Revised Study Plan

Lawrence Hydroelectric Project
(FERC No. 2800)

April 10, 2024

Appendix B – Essex Response to Comments on the PSP

Figure 6-2. Proposed stationary receiver placement for monitoring upstream passage effectiveness at the Lawrence Project

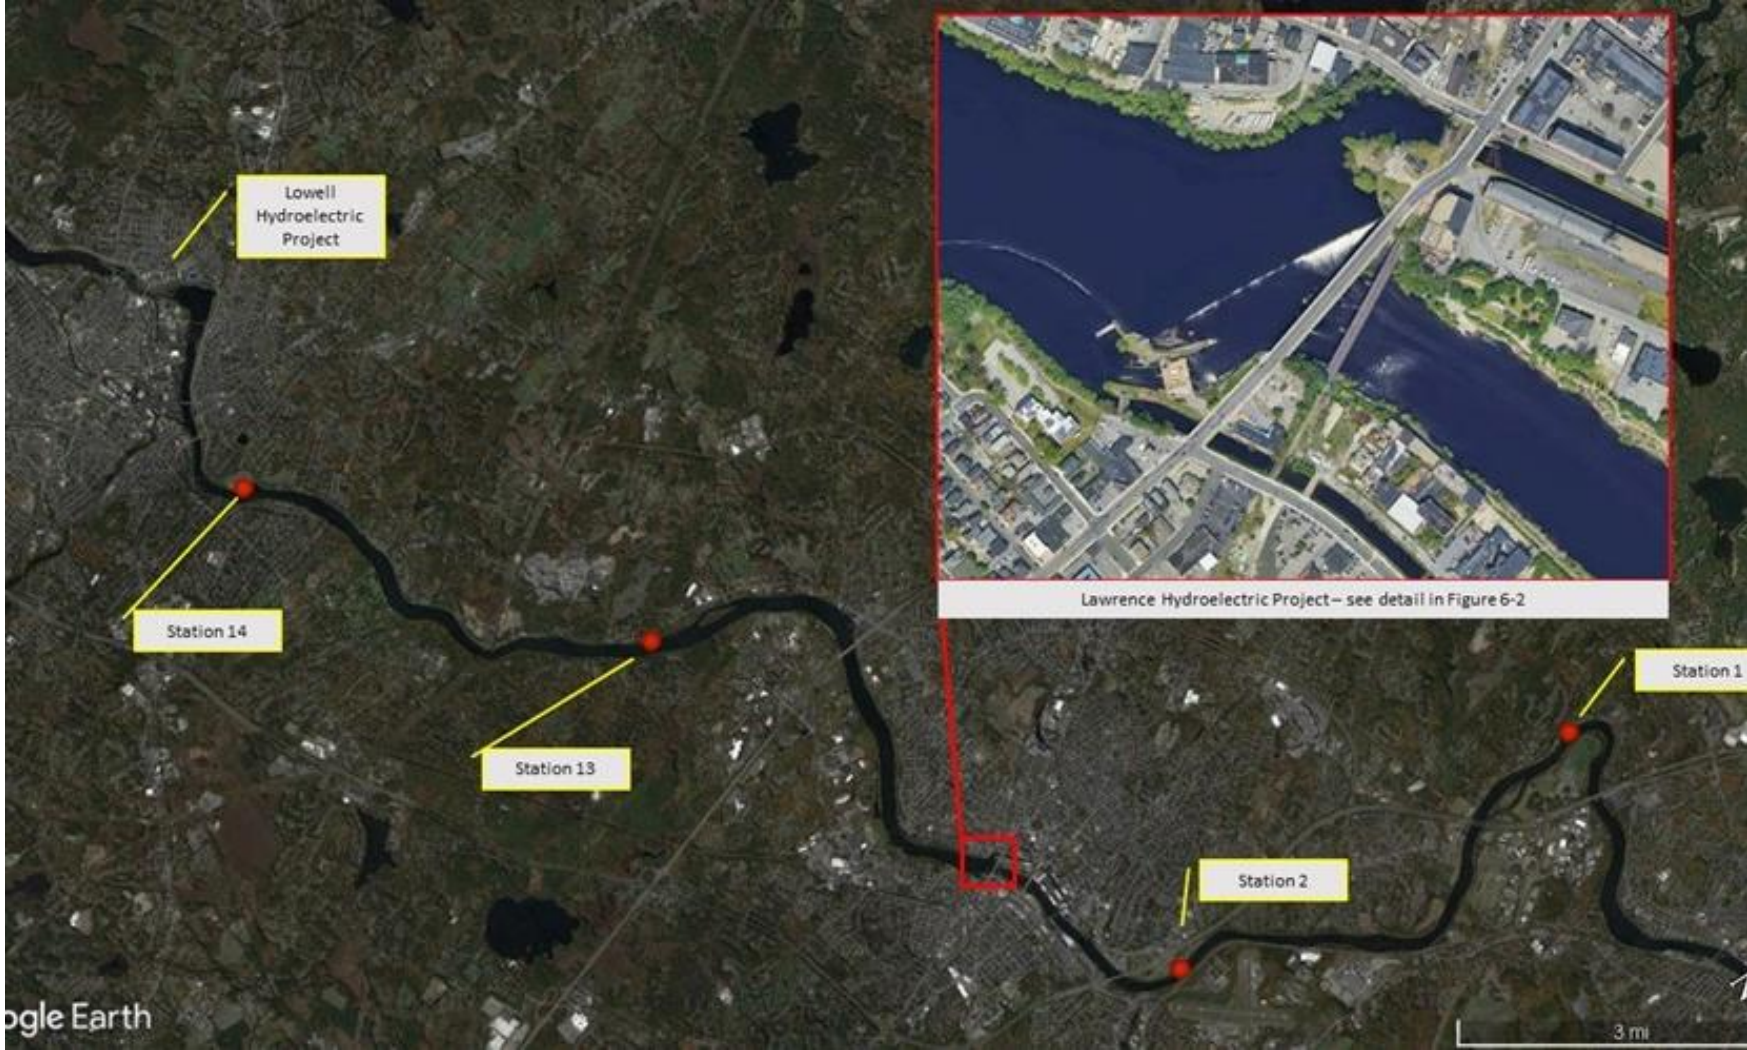
In Section 6.6.3, *Radio Telemetry Monitoring Stations*, Essex proposes to establish and monitor 10 monitoring stations. However, as demonstrated in Figure 6-2 of the PSP, none of the proposed monitoring stations would be situated to monitor (1) how fish approach the Project, (2) false attraction to the Project’s spillway, (3) milling or disorientation in the tailrace, or (4) fish passage success and escapement through the Project’s headpond. As such, MA DMF recommends the addition of the following monitoring station(s):

Please see below the modified Figure 6-2 from the PSP to illustrate the added antennae needed (red ellipses) surrounding the powerhouse and spillway:

In Section 6.6.3, *Radio Telemetry Monitoring Stations*, Essex proposes to operate 10 monitoring stations. However, as demonstrated in Figure 6-2 of the PSP, the proposed arrangement of the monitoring stations would not capture (1) how fish approach the Project, (2) false attraction to the Project's spillway, (3) milling or disorientation in the tailrace, or (4) fish passage success and escapement to the Project's headpond. As such, we recommend the addition of the following monitoring station(s):

USFWS (March 11, 2024)	Upstream Anadromous Fish Passage Assessment (PSP Section 6)	<p>In Section 6.6.3, Radio Telemetry Monitoring Stations, Essex proposes to operate 10 monitoring stations. However, as demonstrated in Figure 6-2 of the PSP, the proposed arrangement of the monitoring stations would not capture (1) how fish approach the Project, (2) false attraction to the Project's spillway, (3) milling or disorientation in the tailrace, or (4) fish passage success and escapement to the Project's headpond. As such, we recommend the addition of the following monitoring station(s):</p> <ul style="list-style-type: none"> • To assess how fish approach the Project, we recommend the addition of monitoring station(s) located immediately downstream of the Union Street Bridge between stations 2 and 3. The station(s) should be oriented to provide data that describe a tagged fish's position within the river reach downstream of the bridge as it approaches the Project. • To track and monitor false attraction to the Project's spillway, we recommend the addition of monitoring station(s) located immediately downstream of the Project's spillway.11 • To assess delay and far field attraction to the Project's fishway entrances, we recommend the addition of an array at the downstream end of the tailrace between stations 3 and 4. • To document fish passage success and escapement to the Project's reservoir, we recommend the addition of a monitoring station just upstream of the Project's intake channel/power canal. 	On March 28, 2024 and April 1, 2024, Essex held a call to discuss the Upstream Anadromous Fish Passage Assessment with the MRTC. Among items discussed was the addition of monitoring stations. Essex updated the study plan in Section 6 of the RSP accordingly. Essex also intends to perform the Diadromous Fish Behavior, Movement, and Project Interaction Study as proposed in Section 11.

Commentor (Filing Date)	Study Name	Comment	Essex Response to Comment
MADMF (March 11, 2024)	Upstream Anadromous Fish Passage Assessment	<p>In Section 6.6.3, Radio Telemetry Monitoring Stations, Essex proposes to establish and monitor 10 monitoring stations. However, as demonstrated in Figure 6-2 of the PSP, none of the proposed monitoring stations would be situated to monitor (1) how fish approach the Project, (2) false attraction to the Project's spillway, (3) milling or disorientation in the tailrace, or (4) fish passage success and escapement through the Project's headpond. As such, MA DMF recommends the addition of the following monitoring station(s):</p> <ul style="list-style-type: none"> • Area below the Duck Bridge as fish approach the Project flows (below proposed Station 3, covering the approach to the immediate project flows); • Coverage for the entire area below the spillway to identify area of false attraction under all flow conditions encountered during the study (between proposed Stations 3 and 4); • Area between the rock face on river right and the stone abutment separating the spillway and powerhouse flows to identify fish that have entered the flow field of the powerhouse and fishway (between proposed Stations 3 and 4, identifying fish that have entered the tailrace and are available for passage); • Coverage of the start of the northern (river side) fishway entrance flow field (between proposed Stations 3 and 4); • Two antennas upstream of Station 9 to identify fish that drop back into the intake and bypass flows after exiting the exit flume and those that eventually depart the immediate vicinity of the powerhouse; • An antenna at the upstream limit of the Project's impoundment help determine predation and delay in the impoundment and a second antenna upstream of that to provide a viable detection probability for the antenna at the limit of the impoundment. It is possible that the proposed Station 10 could function as one of these antennas or be moved to do so. <p>Please see below the modified Figure 6-2 from the PSP to illustrate the added antennae needed (red ellipses) surrounding the powerhouse and spillway:</p>	<p>On March 28, 2024 and April 1, 2024, Essex held a call to discuss the Upstream Anadromous Fish Passage Assessment with the MRTC. Among the items discussed was the inclusion of additional monitoring stations as part of the Upstream Anadromous Fish Passage Assessment. As added to Section 6.6.3 of this RSP, Essex added Station 4 to better detect passage at the lower portion of the downstream tailrace below the powerhouse, and Station 11 to provide detection information for radio-tagged fish having exited the upstream exit flume of the Lawrence fish lift and moved into the Project forebay. Station 12 was added to inform on radio-tagged individuals which have exited the upstream exit flume of the Lawrence fish lift and moved upstream to the point where they are exiting from the powerhouse forebay. In addition, Station 14 will be the furthest upstream location monitored for radio-tagged test fish and will be installed along the mainstem of the Merrimack River at a point between Station 13 and the Lowell Project.</p> <p>Where appropriate, Essex will capture fish behavior in the Diadromous Fish Behavior, Movement, and Project Interaction Study, which has been provided in Section 11 of this RSP.</p>
